VILLAGE OF TUSCARAWAS
TUSCARAWAS COUNTY, OHIO

CHERRY ST WATER LINE REPLACEMENT & STORM SEWER IMPROVEMENTS

ADDENDUM #1

THRASHER PROJECT #T10-11077

SIDEWALK TRENCH REPAIR
NOT TO SCALE

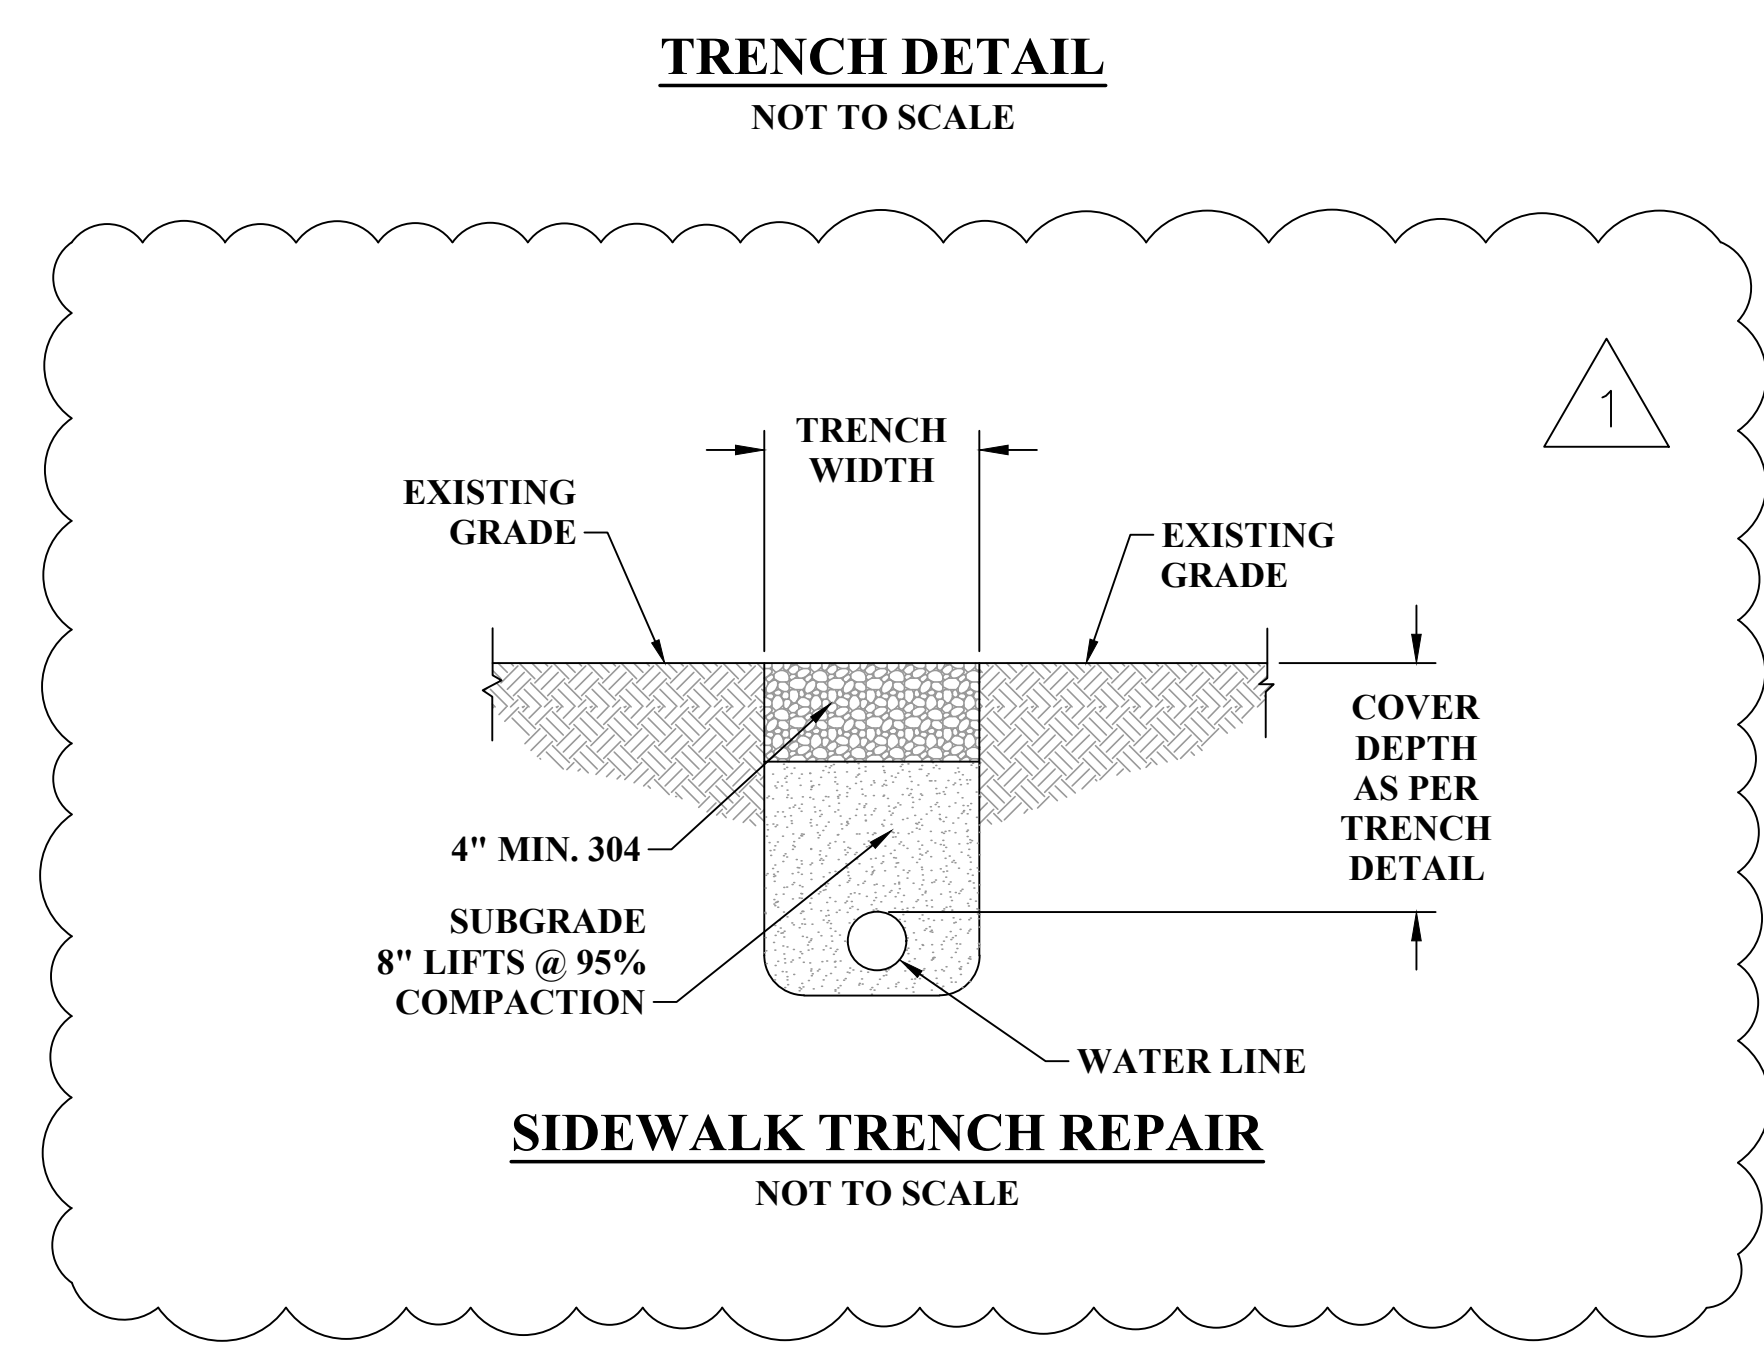
6. QUESTION

I don't see a sidewalk detail in the prints. Does the sidewalk get compacted granular backfill or dirt under the sidewalk? Can you provide a trench detail for under the sidewalk and a sidewalk detail.

RESPONSE

6" of ODOT 304 aggregate will be used as a temporary walkway in areas where sidewalk is removed.

RESPONSE

See response to Question 4. (See attached Sheet D2)
